**From:** Richard Guerin  
**Sent:** 04 February 2025 7:59 PM  
**To:** council@northernbeaches.nsw.gov.au  
**Subject:** Submission for DA2024/1814

16 McDonald St (N16) are the adjoining owners – east facing and immediately behind N20 McDonald Street. Having carefully reviewed in depth the DA submission for N20 McDonald Street, N16 have several concerns related to privacy bulk and scale and respectfully request clarifications and a considered review of DA 2024/1814 as the proposal will negatively impact privacy, sunlight and enjoyment of the amenity and on respective neighbouring properties as outlined below.

## **Review and assessment of DA 2024/1814 and Impacts to N16 McDonald Street:**

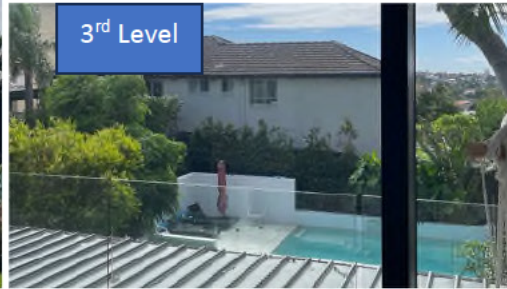
There is currently overlooking into N16 from one primary bedroom window – the remaining windows are a bathroom & toilet as per picture below taken from an internal bedroom. There are 2-bedroom windows facing N18 that are partially screened by N18 hedging.

In the DA proposal, there will be direct overlooking by 3 new windows facing N16 property circa 1 meter from the rear boundary, with overlooking from 8 additional windows which face N18 / or are facing south (including the 3<sup>rd</sup> level), and a south facing bedroom with balcony that will enable views back into N16 liveable areas.

View from N16 rear deck area & from 1<sup>st</sup> floor bedroom at No16. With superimposed new windows and 3<sup>rd</sup> floor.

- It is requested that the proposed N20 windows directly looking into N16 are changed to 'highlight' windows - i.e. windows with a high sill height (above eye level) that can still provide light and airflow but give better privacy (noting the N20 proposed windows also have skylights, to allow for adequate light and airflow) and consider fixed aluminium privacy screens similar to N18 and consistent with other properties within the Freshwater area and as instructed by Northern Beaches Council to ensure privacy, reduce light and noise for adjoining N16 and N 18 neighbours.
